**STAFF REPORT
DEVELOPMENT COMMISSION
ZONING MEETING
CITY OF COLUMBUS, OHIO
JANUARY 9, 2014**

- 2. APPLICATION: Z05-079 (13335-00000-00883)**
Location: **6490 HARLEM ROAD (43054)**, being 16.4± acres located at the southeast corner of Harlem and Central College Roads (010-273451 & 010-249767; Rocky Fork Blacklick Accord).
Existing Zoning: R, Rural District.
Request: PUD-8, Planned Unit Development District.
Proposed Use: Multi-unit residential development.
Applicant(s): Sugar Run at New Albany Park, Ltd; c/o Michael T. Shannon, Atty.; Crabbe, Brown & James, LP; 500 South Front Street, Suite 1200; Columbus, OH 43215.
Property Owner(s): The Applicant.
Planner: Shannon Pine, 645-2208, spine@columbus.gov

PUD-8
SITE PLAN

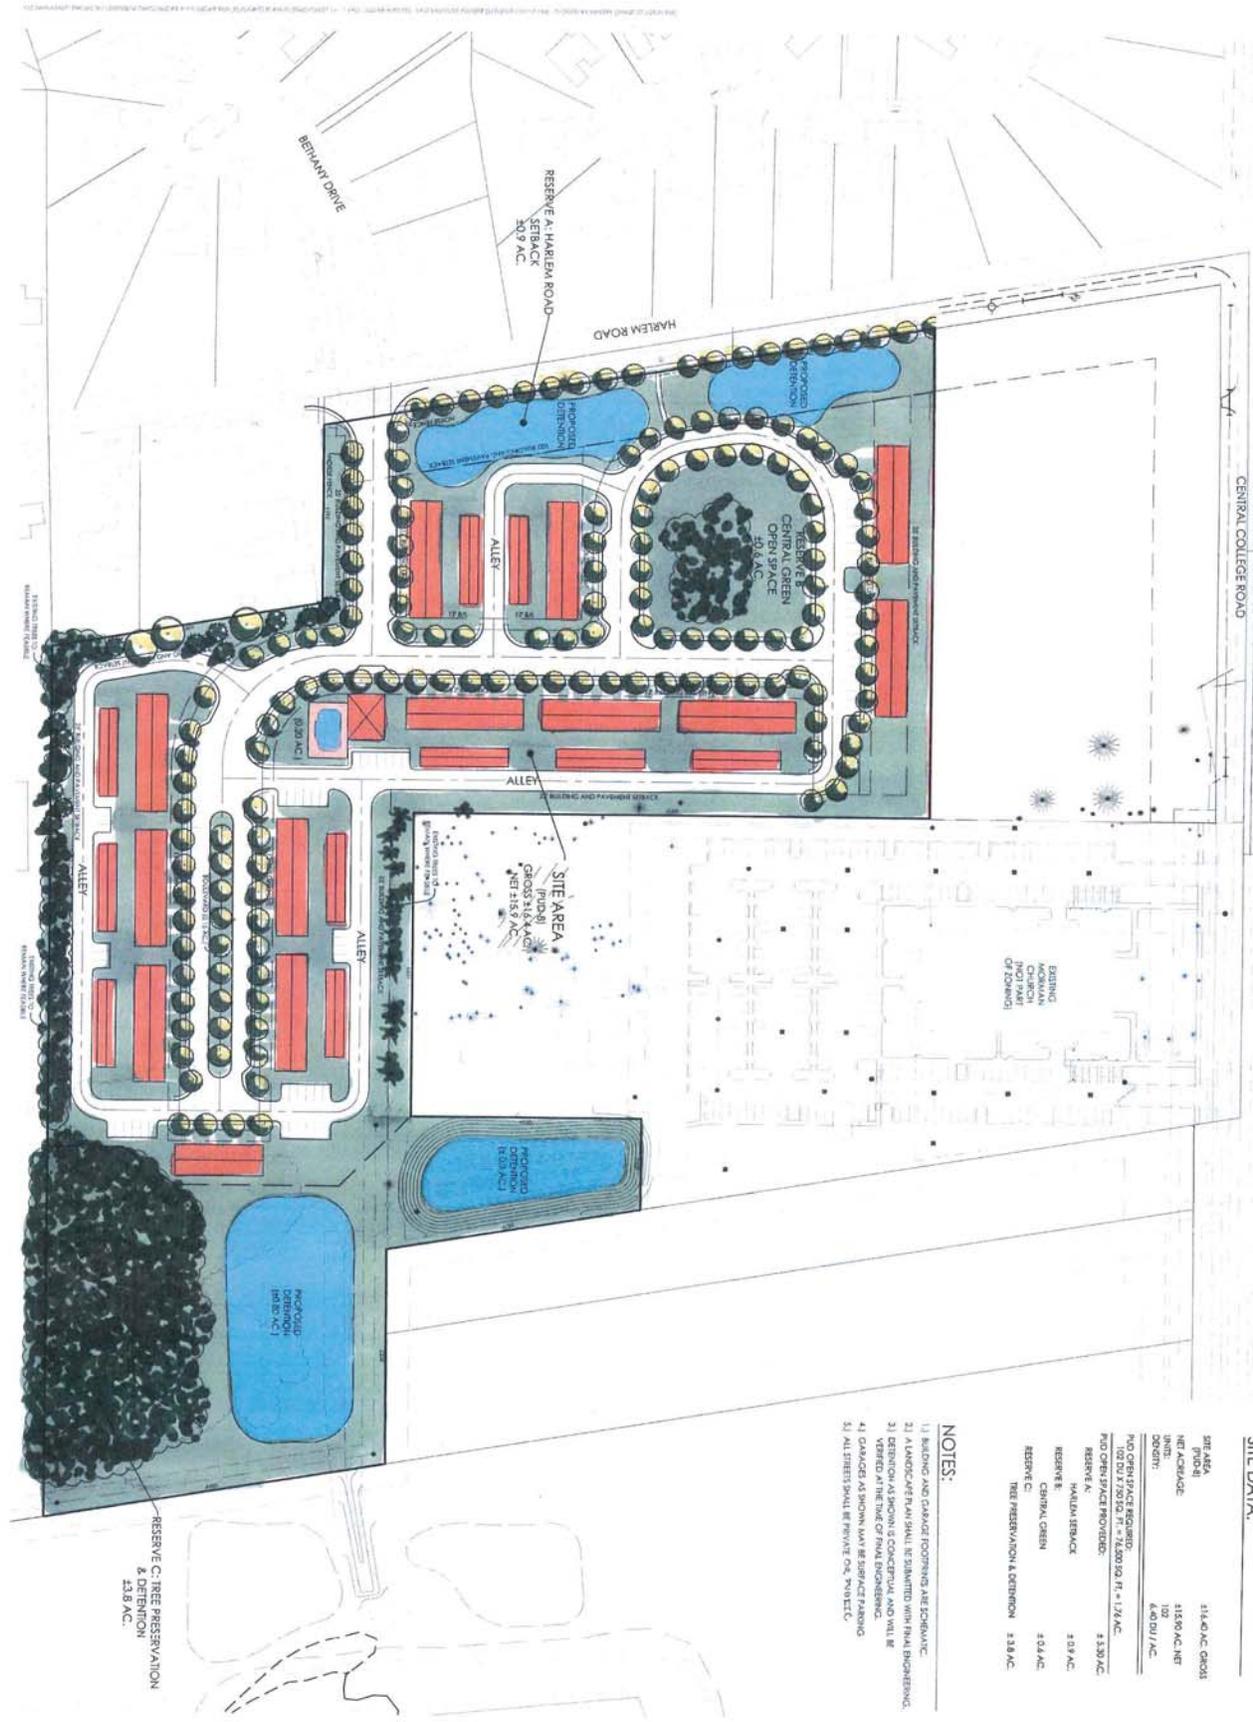
Panel Discussion: Panel asked Mr. Brown about smaller garage buildings shown on the site. Mr. Brown explained that per PUD-8 zoning, the site plan is final for street layouts and open space but building footprints might change depending on circumstances. However, treatment of Harlem Road in terms of end of the buildings would be maintained.

Panel asked about some of the changes made to the site plan in comparison to previous proposal. A question was raised to address the treatment to central open space and type of plant material that will be used along Harlem Road. Mr. Brown explained that though he does not have specific names for plant material, the plan will be developed by registered landscape architect and landscaping text follows zoning and RFBA landscaping and buffering requirements. There will be 4' fence provided along Harlem Road.

Other concerns raised were the process to preserve existing tree cover during and after development of site. Applicant agreed to protect the trees using snow fence to protect the trees.

Panel asked about treatment of the building ends facing Harlem Road; applicant assured that brick will be used to treat the building façade.

- Snow fences around existing tree cover in central open space and southwest open space.
- All buildings will be two stories.
- Fenestration on all four sides.
- The primary building material will be Brick for building façade/s facing Harlem Rd including southern most building.
- Special consideration to landscaping and buffering will be given to southwest corner for headlight shielding.
